# WILLIAMSON COUNTY, TEXAS

CHANGE ORDER NUMBER: 15

Project:	<u>13IFB00108</u>
Roadway:	<u>IH 35 NBFR</u>
CSJ Number:	<u>0015-09-128, etc.</u>

**3F: County Convenience. Additional work desired by the County.** This Change Order adds new Contract items and additional quantities for the installation of three permanent traffic counters to quantify traffic on the IH 35 northbound frontage road. The counters are necessary to fulfill the requirements for TxDOT to reimburse Williamson County in accordance with the Pass Through Financing Agreement No. PT2010-006-01. This Change Order is eligible for FHWA reimbursement.

FED. RD. DIV. NO.	FEDERAL AID PROJECT NO.	SHEET NO.
6		162B

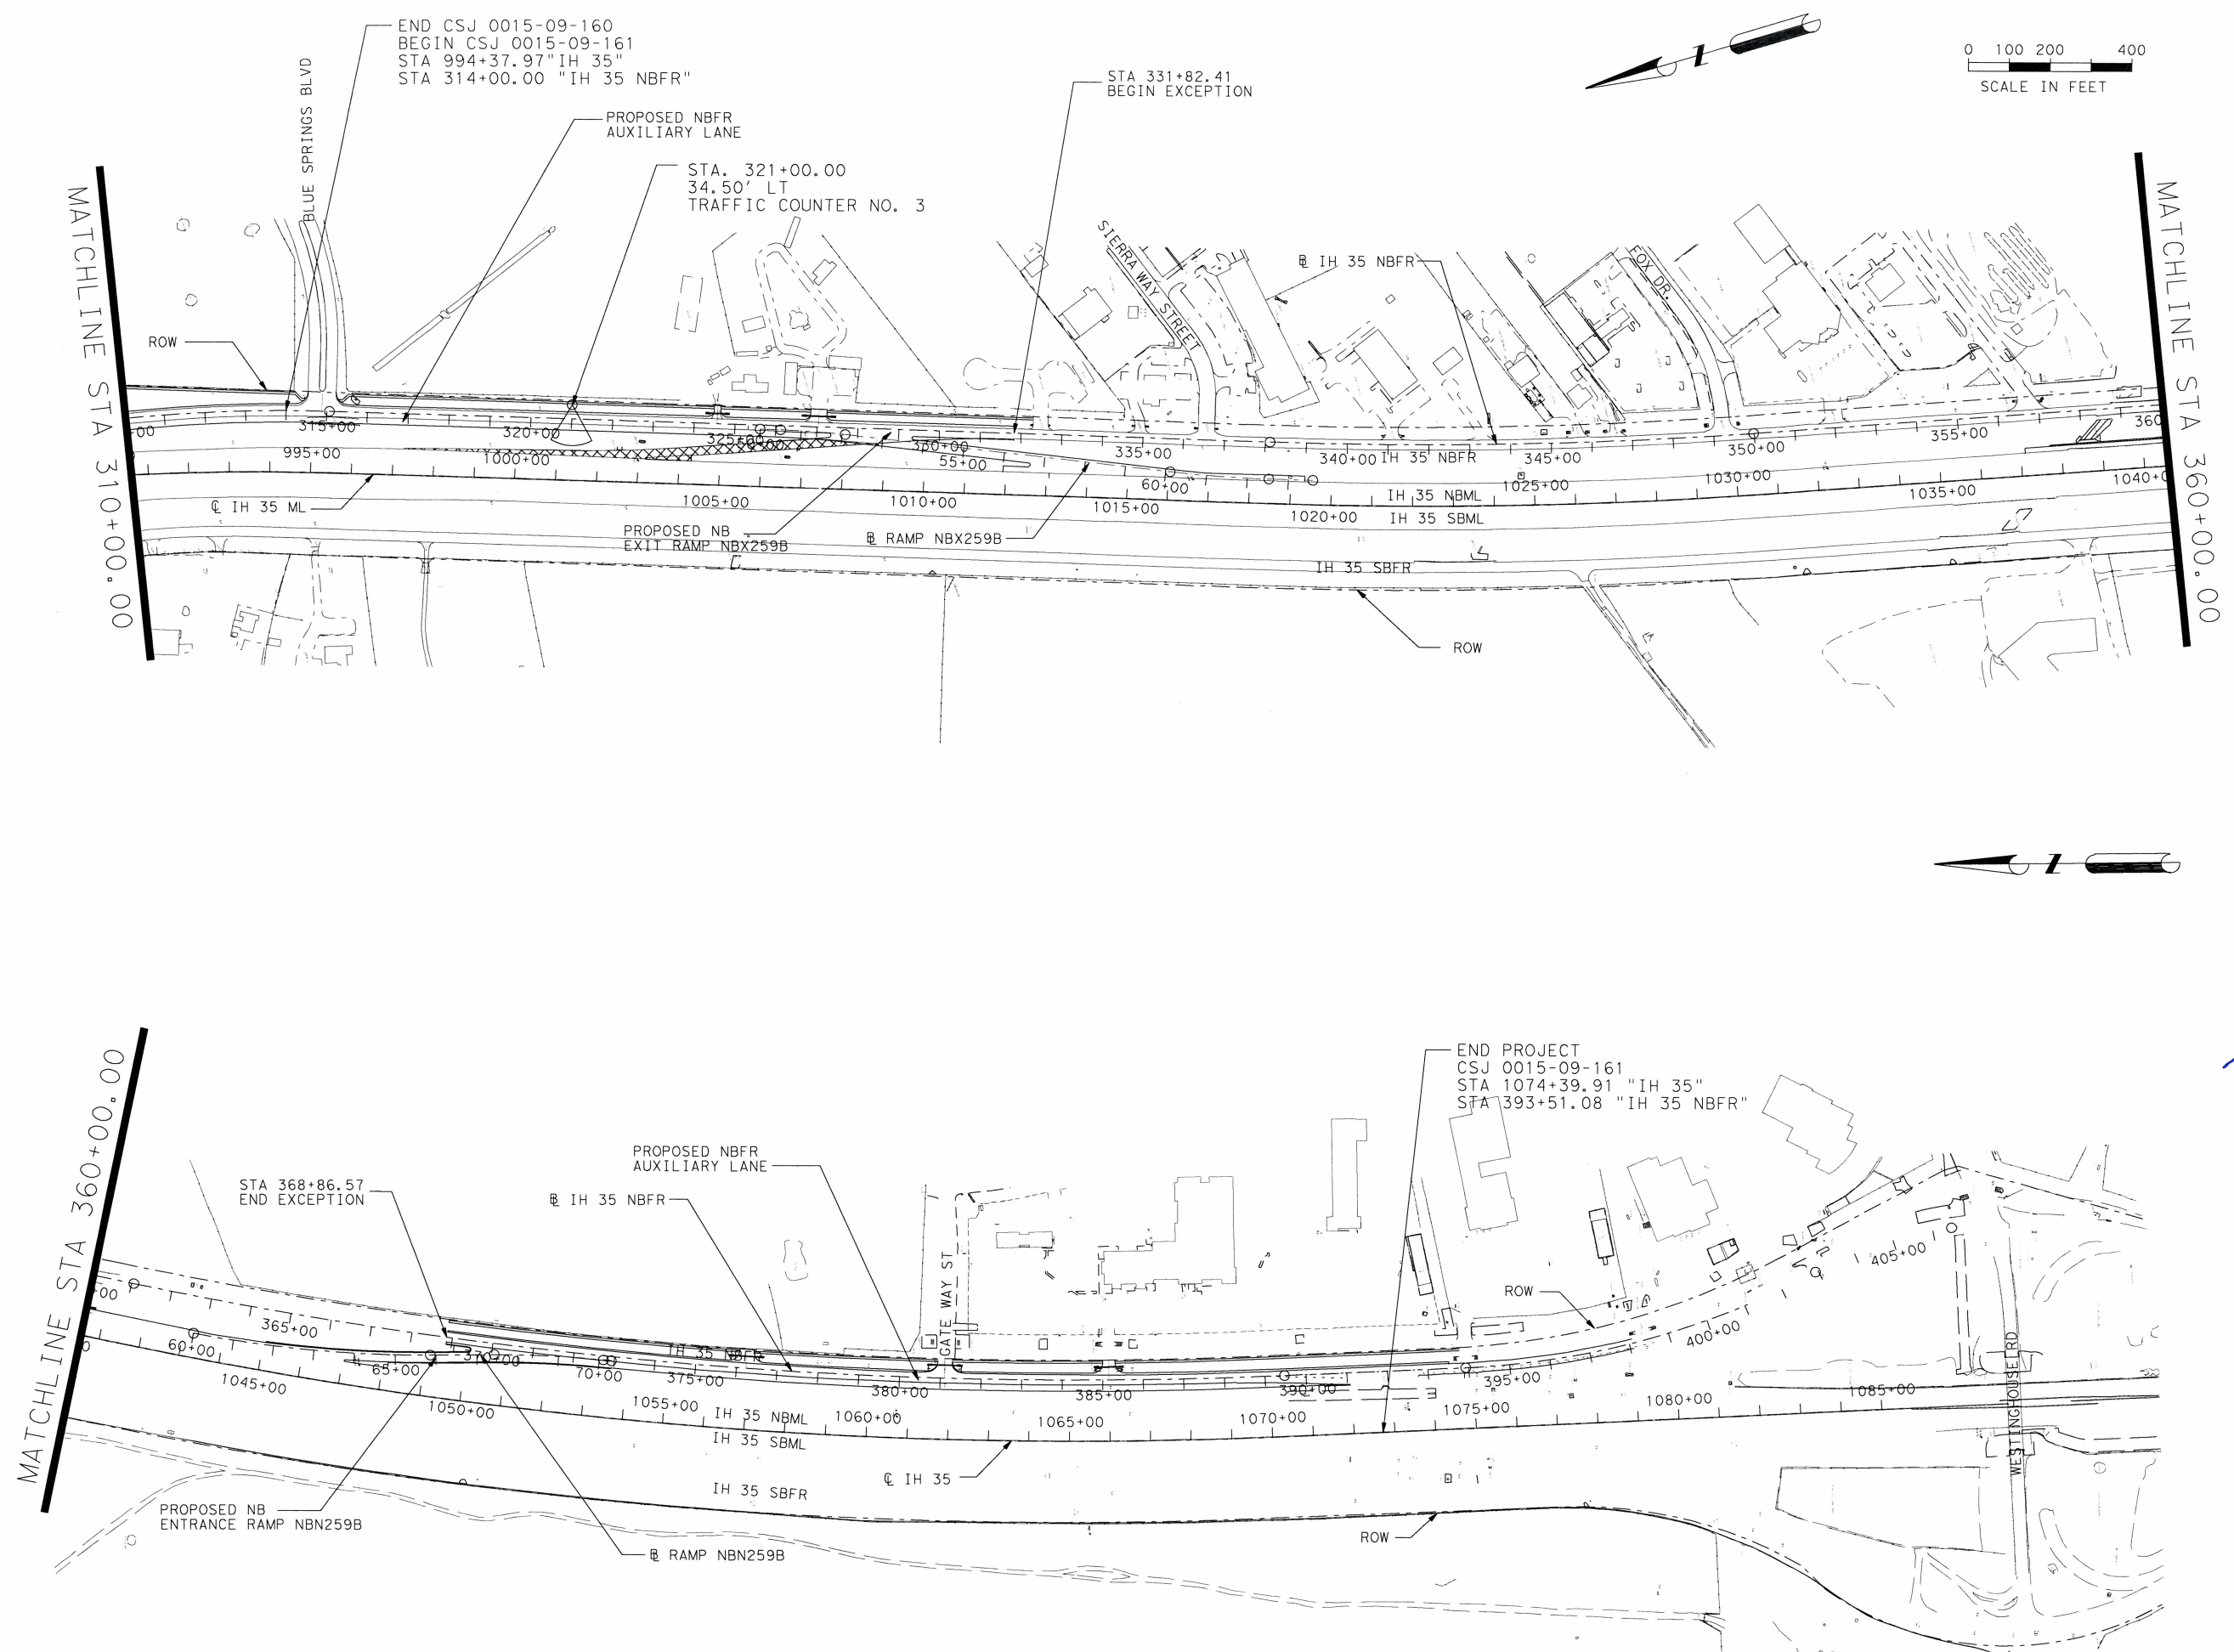
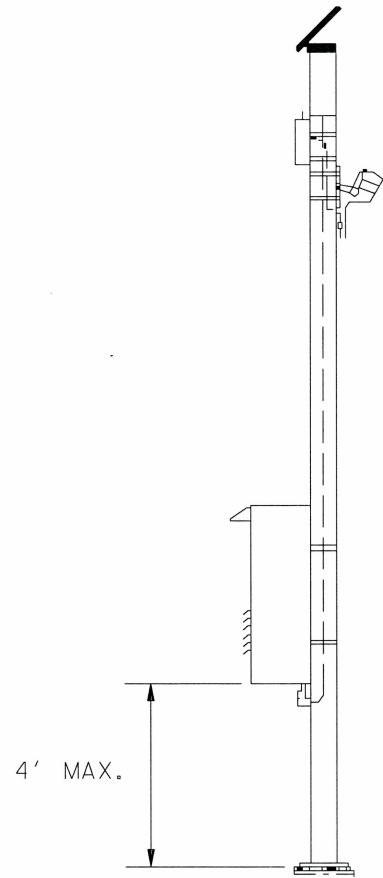
STA. 321+00.00  
 34.50' LT  
 TRAFFIC COUNTER NO. 3
